# **AEROPRAKT**

## **SERVICE BULLITEN**

### **No. SB A-32-05**

Modification of the all-moving horizontal tail (AMHT) of A32 aircraft.

**Fig. 2.**

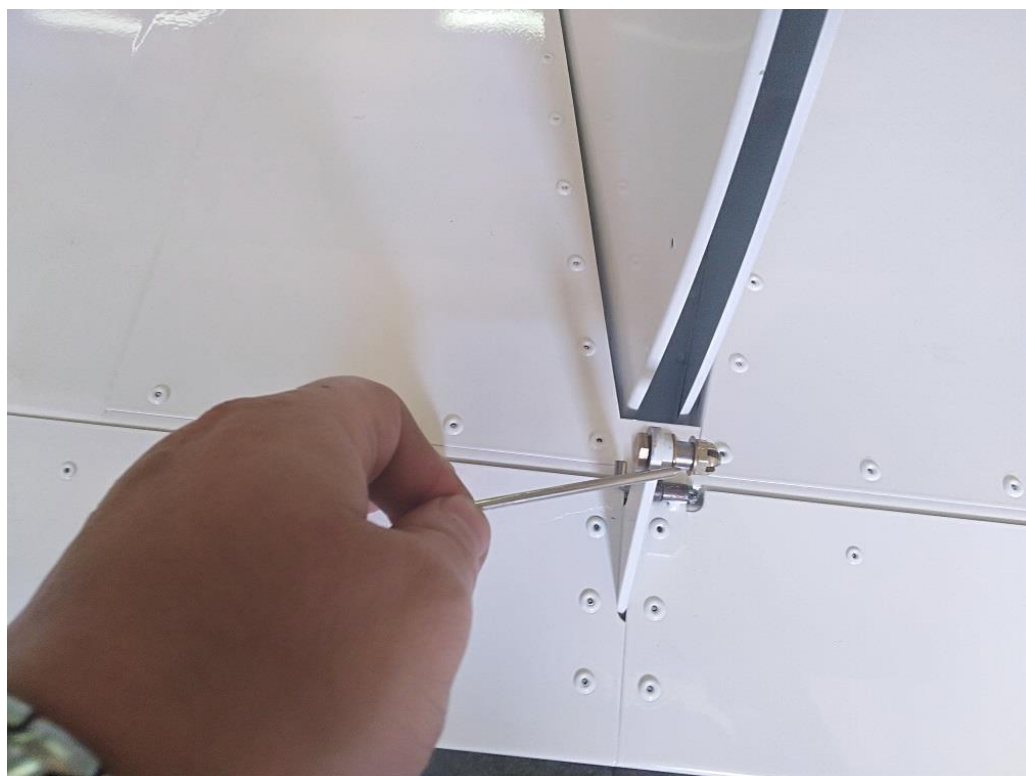
3.2) Disconnect the AMHT (all-moving horizontal tail) antiservo/trim tab control cable (Fig.2).

**Fig. 4.**

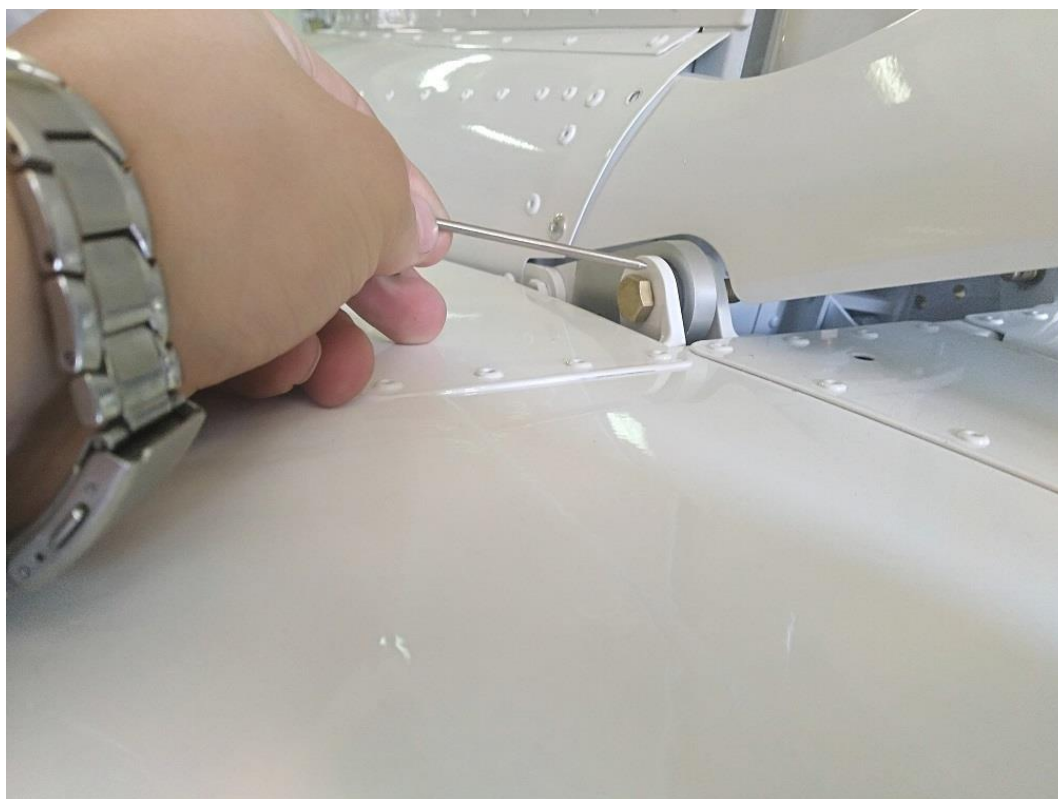
3.4) Remove the AMHT by undoing its two attachment bolts (Fig. 4).

**Fig. 5.**

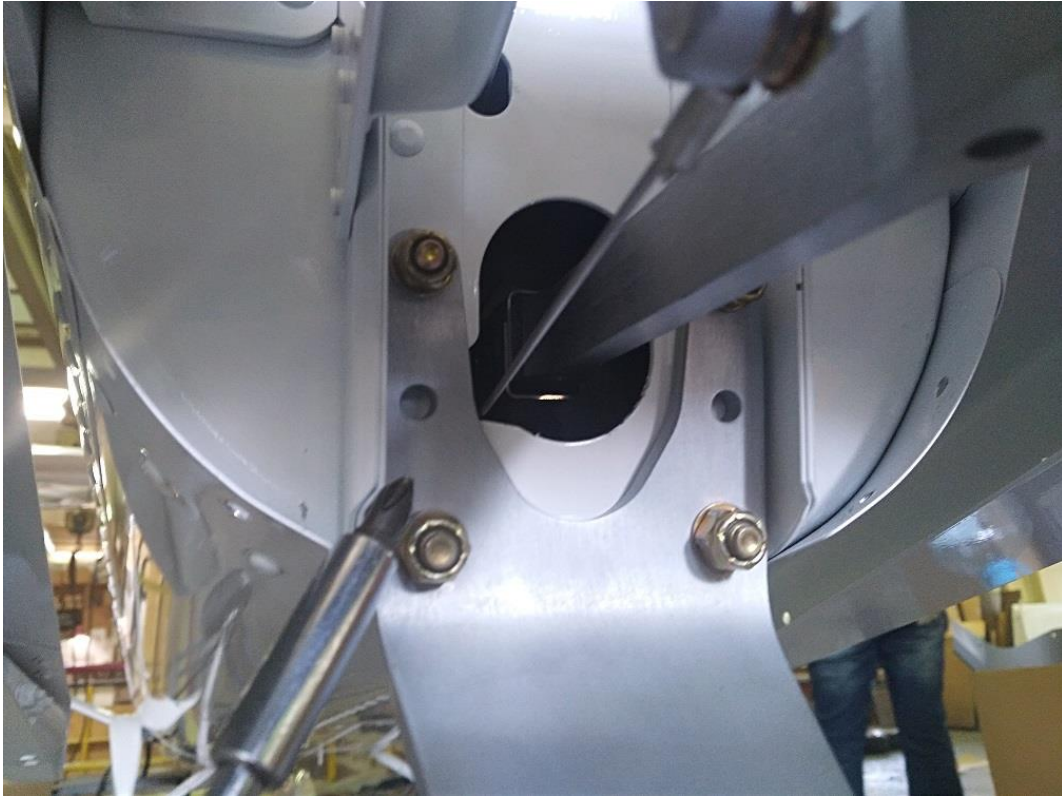
3.5) Remove the tail skid from the frame No. 10 (Fig. 5).

Fig. 7.

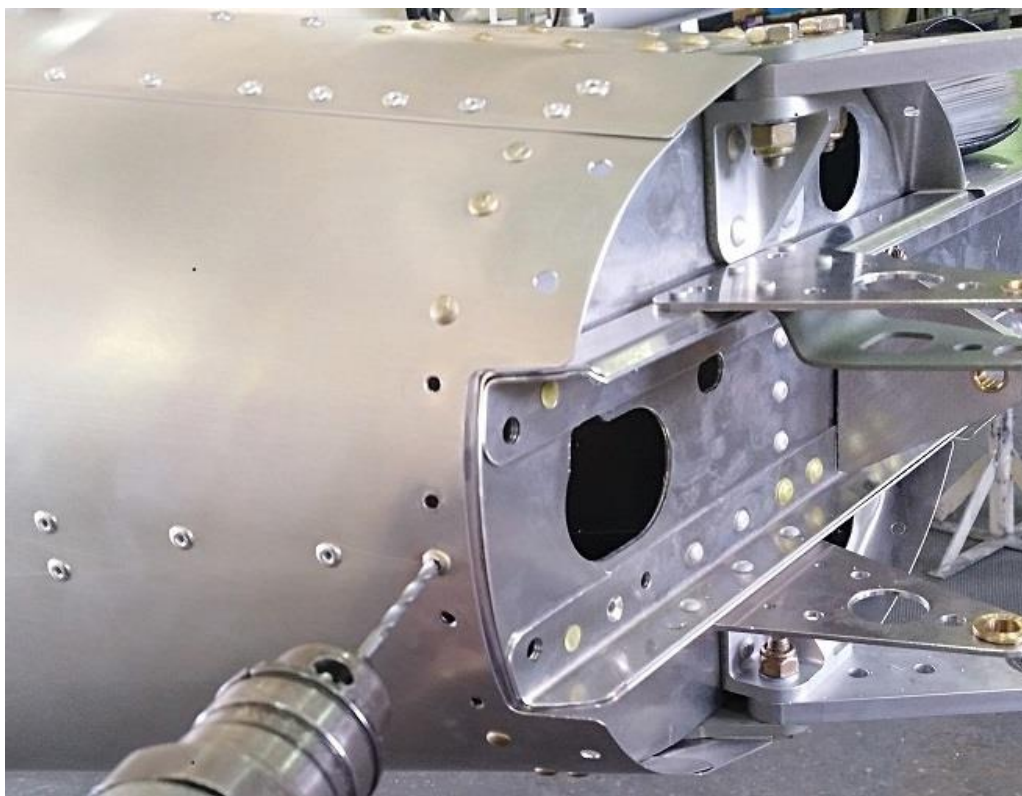
3.7) Undril 5 rivets on the bottom side of the tail boom at the frame No. 10 (Fig 7).

**Fig. 10.**

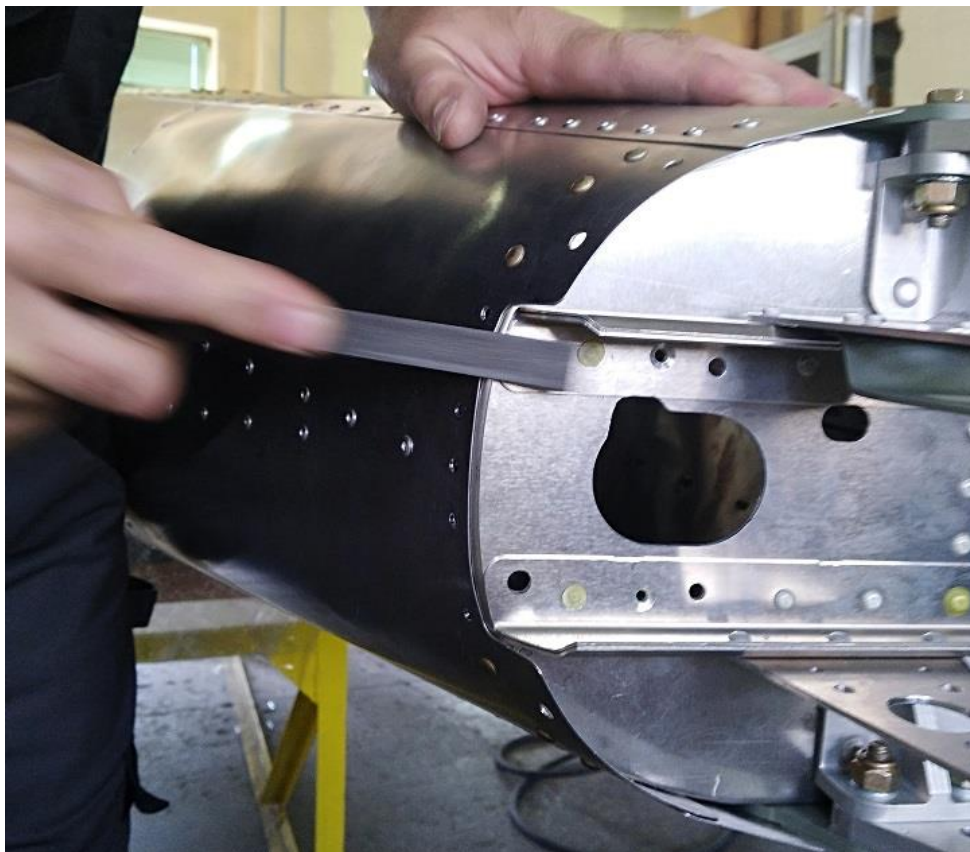
**3.10)** Round the sharp edge of the fin spar flange to ensure a better fit of the doubler (Fig. 10).

Fig. 11.

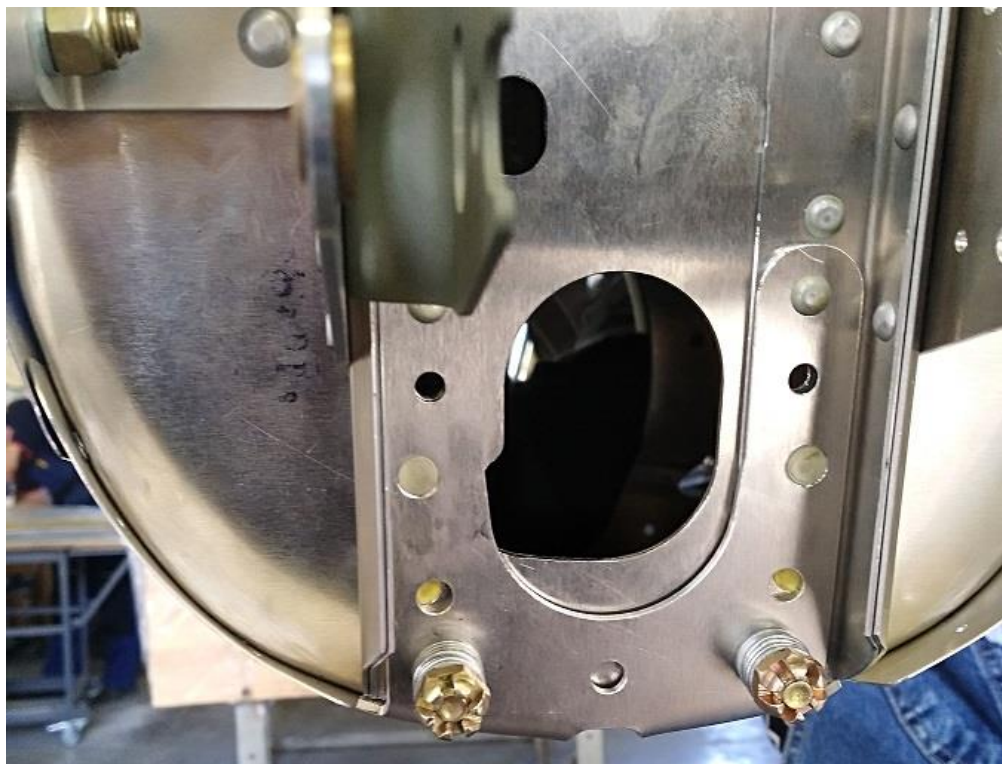
**3.11)** Attach the doubler with temporary bolts, install two rivets with flush heads and two rivets with normal heads on the fin spar (Fig. 11).

Fig. 12

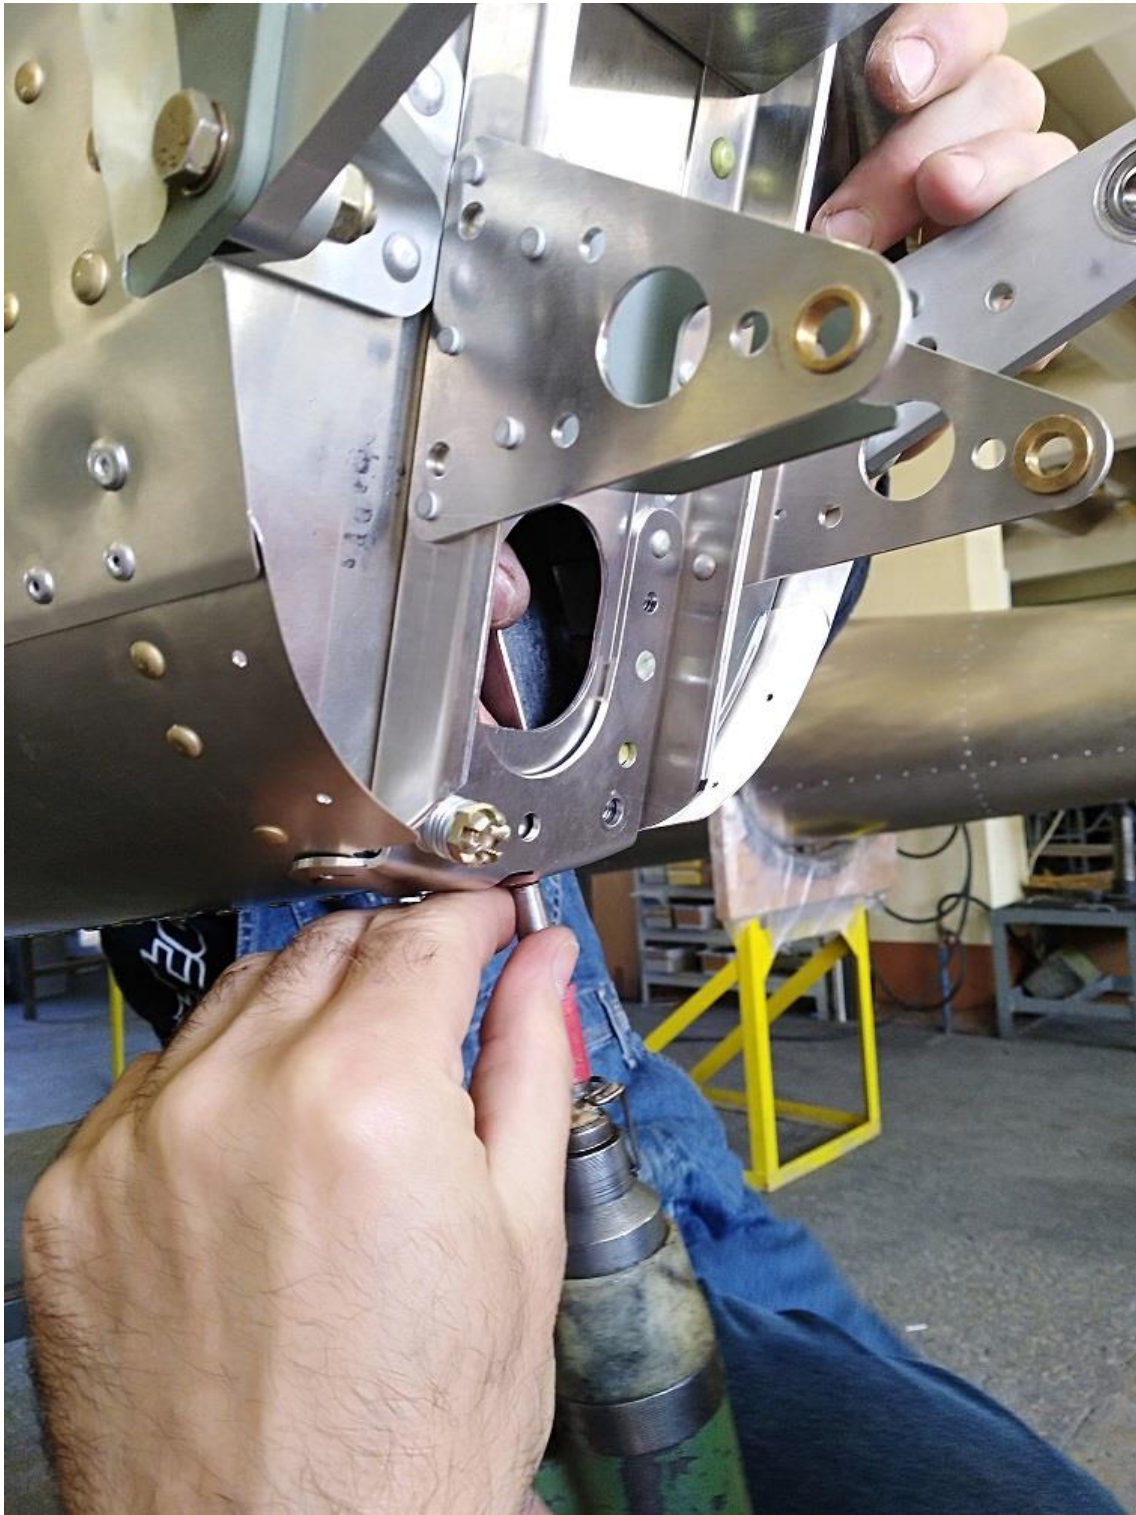
3.12) Install the rivets on the flanges of the doubler (Fig. 12).
